Dean Moor Solar Farm

Environmental Statement: Appendix 7.8 – Arboricultural Impact Assessment

26 August 2025
Prepared by: Stantec UK Ltd
PINS Ref: EN010155
Document Ref: D2.17
Deadline: 2
Revision: 2

Table 1.1: Revisions to Appendices B and C of the AIA

Appendix C Tree Protection Plan

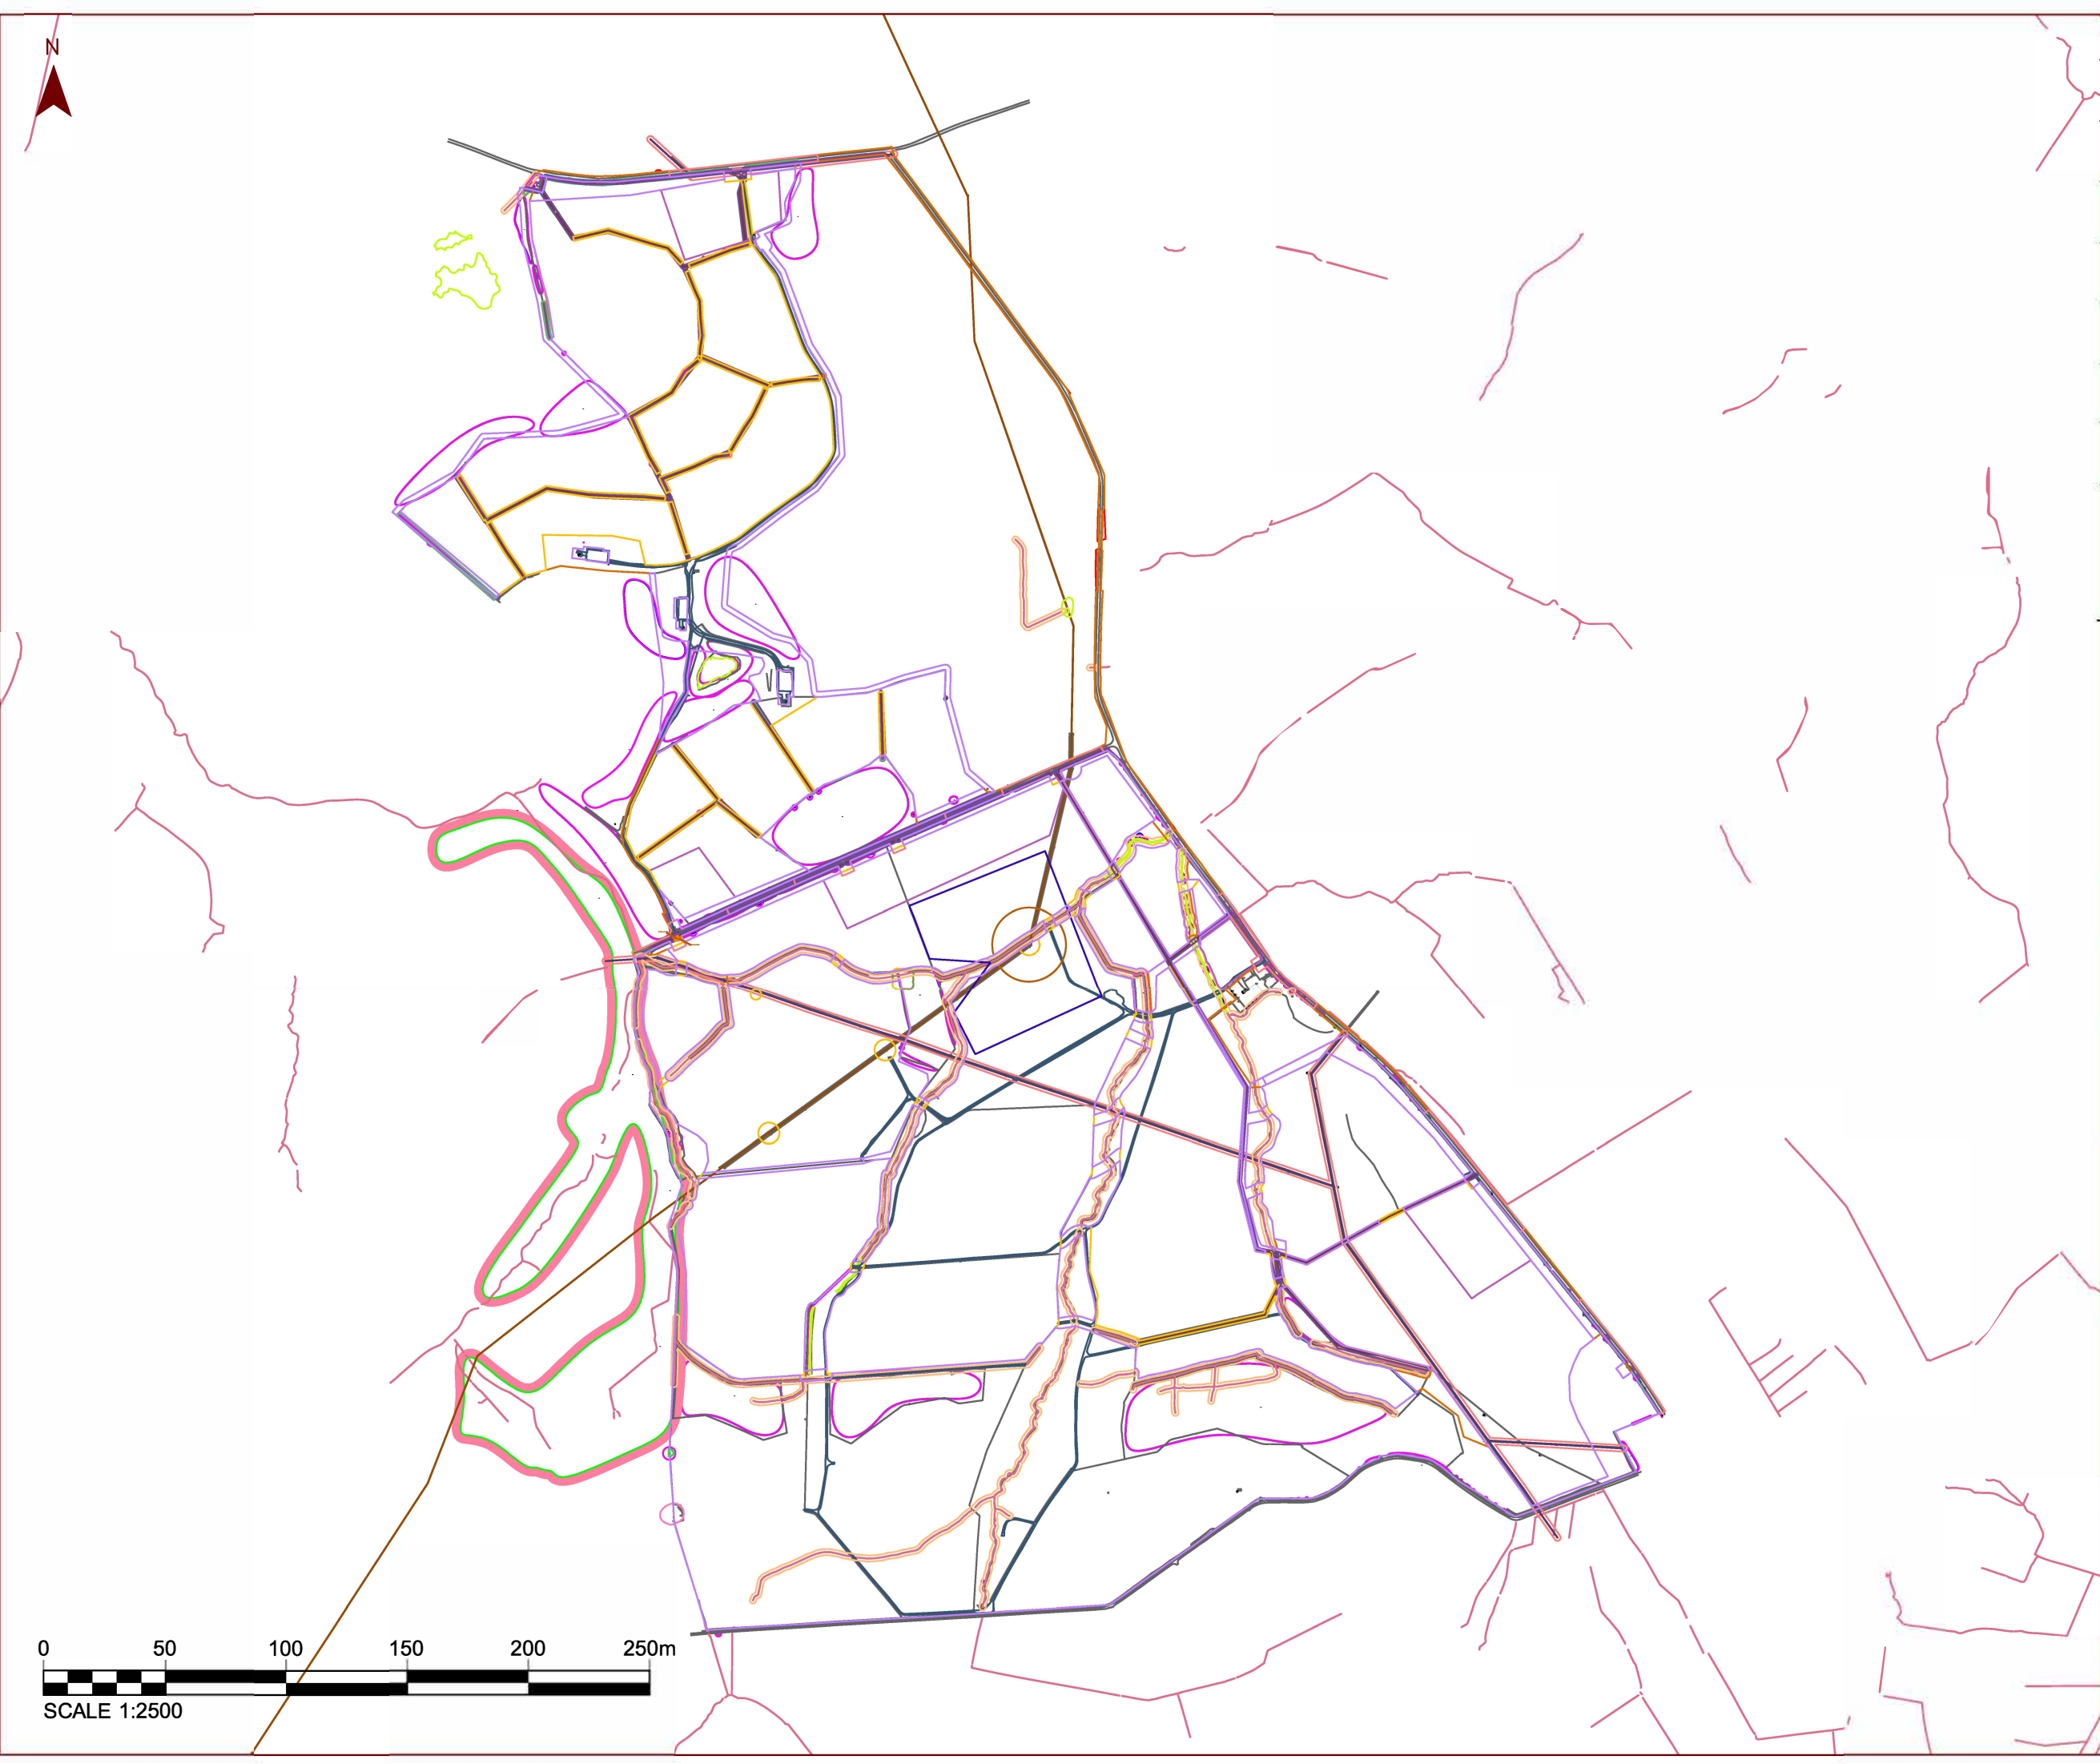
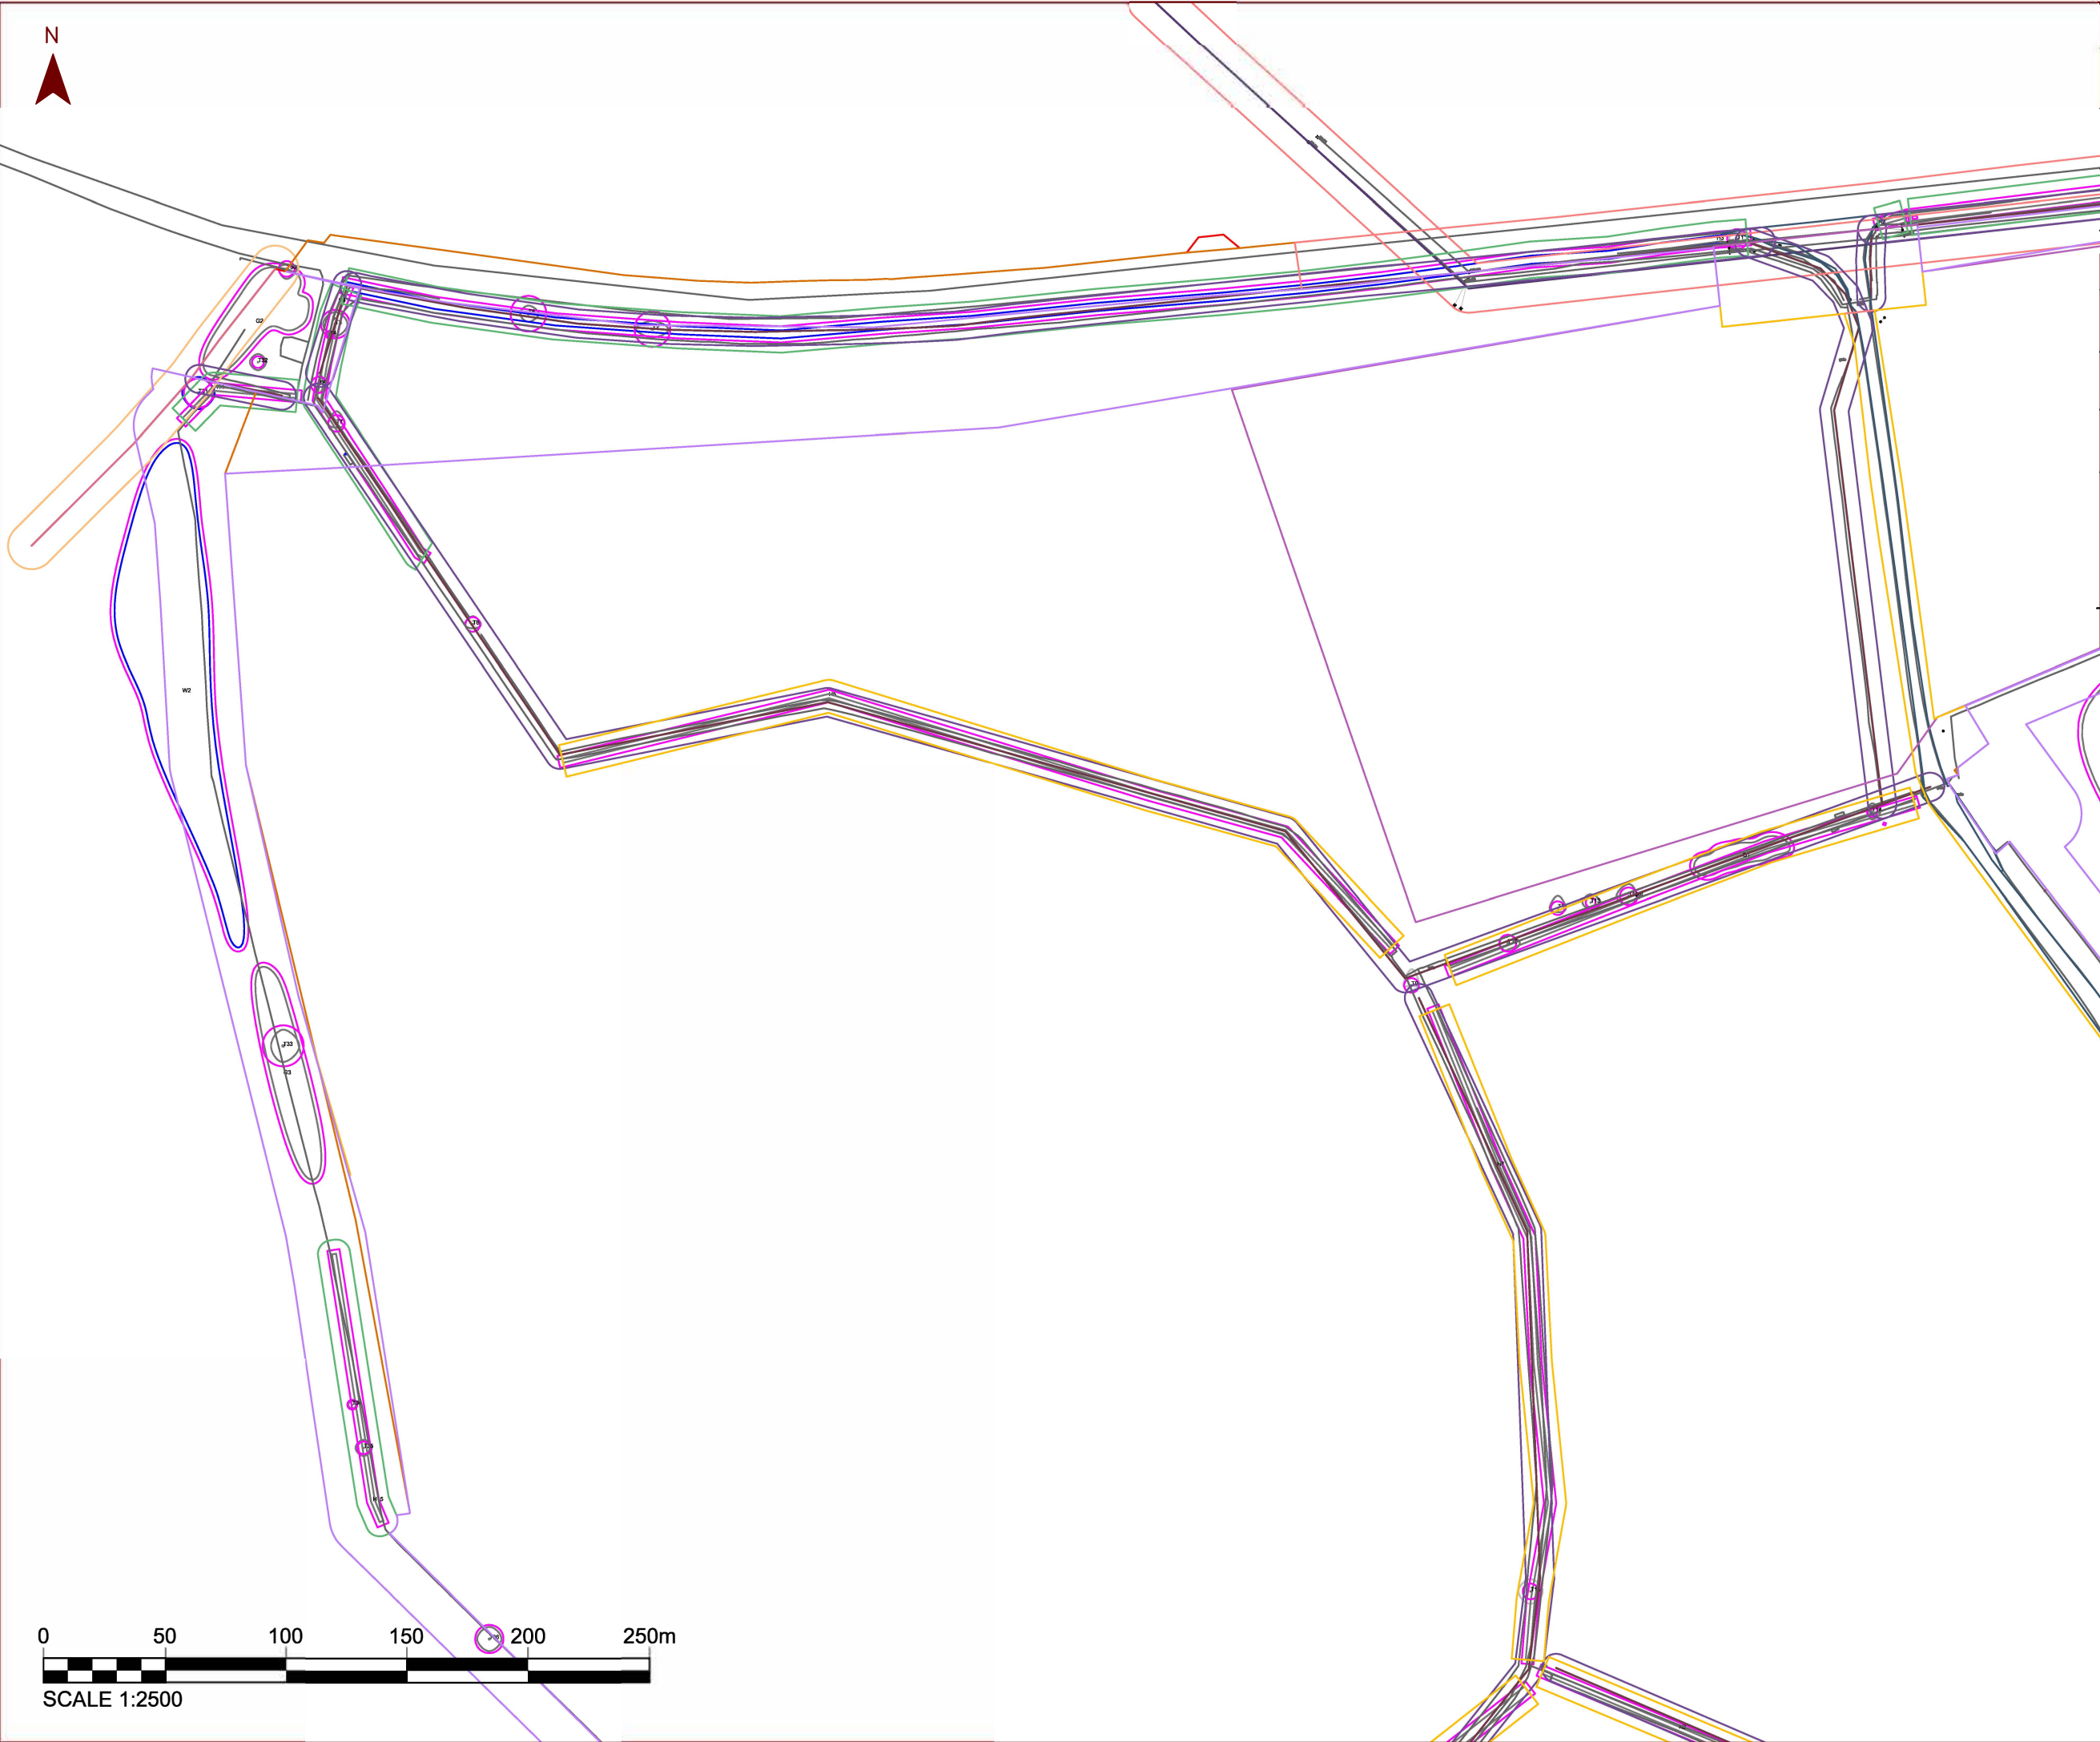
Revision	Reason
Change of the plan title in the TCP from 'Location Plan' to 'Tree Constraints Plan'	To make it clear that the plan is displaying the TCP. As the Location Plan is a different figure within the ES.
A renumbering of the sheets included in the TCP. Changing the order from 0-22 to 1-23.	To enable the first sheet within the TCP is numbered 1 rather than 0.
Change of the plan title in the TPP from 'Location Plan' to 'Tree Protection Plan'	To make it clear that the plan is displaying the TPP. As the Location Plan is a different figure within the ES.
A renumbering of the sheets included in the TPP. Changing the order from 0-22 to 1-23.	To enable the first sheet within the TPP is numbered 1 rather than 0.
